**RFI 127
Pebble Project EIS**

Title/Subject:	Alternative Road Alignment to Avoid Pedro Bay Corporation Lands
Requestor:	USACE
Date Transmitted:	7/17/2019
Recipient:	Pebble Limited Partnership
Response Requested by:	7/30/2019
Rationale:	USACE received a letter dated July 1, 2019 from Matt McDaniel of Pedro Bay Corporation stating that PBC has not, and will not, consent to PLP's use of its lands for the Pebble Project. The Draft EIS includes Alternatives 2 and 3 which would have the transportation corridor routed across PBC lands.
Describe the Information Requested and Level of Detail:	Please evaluate alternate road/pipeline alignments to determine if there is a reasonable and practicable route on the north side of Iliamna Lake that would avoid PBC lands.

TECHNICAL MEMORANDUM

To: James Fueg
From: RECON, LLC: Steven Rowland, PE
Subject: Response to Pebble Project EIS RFI 127
Date: July 19, 2019

**PEBBLE LTD.
Pedro Bay
Area of Interest**

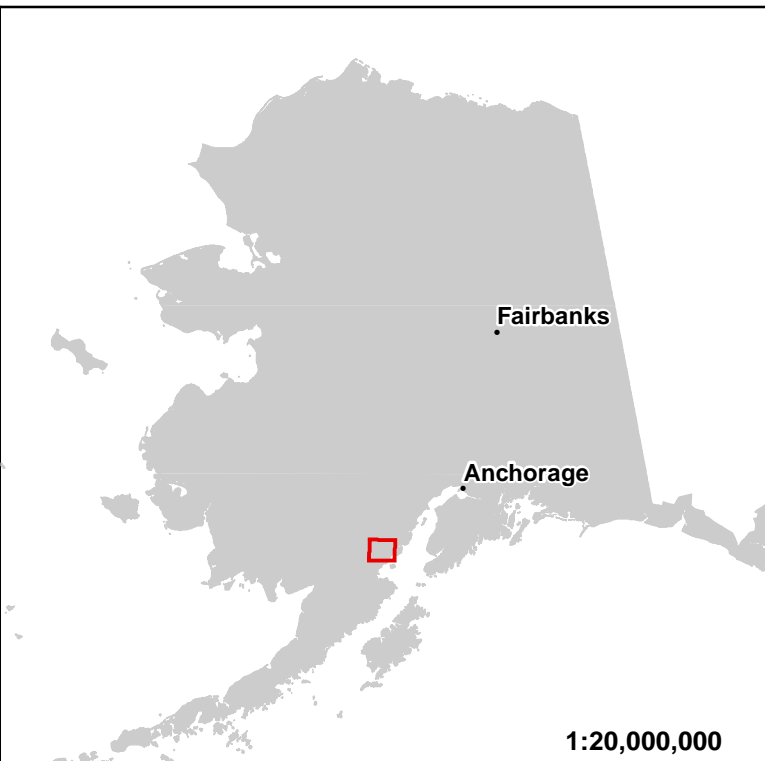
RFI 127 Pebble Project EIS includes the following request: “Please evaluate alternative road/pipeline alignments to determine if there is a reasonable and practicable route on the north side of Iliamna Lake that would avoid PBC lands.”

RECON has completed the requested evaluation and determined that due to adverse terrain conditions no reasonable or practicable route alternative exists.

The area identified for consideration of an alternate road/pipeline route is defined by a narrow corridor north of Pedro Bay Corporation (PBC) land and south of Lake Clark National Park and Preserve (LCNPP). This approximately 40 mile long corridor passes through the Chigmit Mountains, from roughly Chekok Creek on the west end to the head of Iniskin Bay on the east end. The terrain is characterized by north south trending glacial carved valleys separated by steep sloped mountains with high cirques and arête ridges that rise 3,000 to 4,000 feet above the valley floor. There are six major valleys that would be crossed by a road route with five mountainous ridgelines separating each. In addition, a road route would traverse a narrow steep sloped mountain valley and a pass between the Iliamna River and the head of Iniskin Bay. Major river valleys that define the route include the following: Canyon Creek, Knutson Creek, West Branch Pile River, Pile River, West Branch Iliamna River, and Iliamna River. The alternate road route would include at least six mountain passes with elevation ranging from 1,000 to 3,000 feet. The alternate route would also require construction for several miles along the west side of Iniskin Bay to a port site that would have to be developed at a point with deep water access. The road in Iniskin Bay would be constructed in the intertidal zone to avoid rock-slide and avalanche hazards.

Any road/pipeline route north of PBC land would either require 12-15 miles of tunnel or extreme mountain road construction that would be subject to numerous geohazards and impose operational constraints that would be debilitating to mine operations. The constructed road length for the north alternate would be approximately sixty percent longer than the current proposed route through PBC land. Cost to construct a road and pipeline in this terrain would be many times greater than the current identified route through PBC land. The route segment from the head of Iniskin Bay to a functional port site would require location of the road embankment within the intertidal zone; and would be as much as four times the cost of conventional road construction while potentially increasing project environmental impacts. Due to difficulty of construction through the mountainous terrain and in Iniskin Bay, the construction duration would likely be extended by one to two years.

Given the adverse nature of the terrain that exists north of PBC land, and the constraints imposed by design criteria for a road to serve the proposed Pebble Mine; it has been determined that construction and operation of a road that would pass north PBC lands is not practical or reasonable.
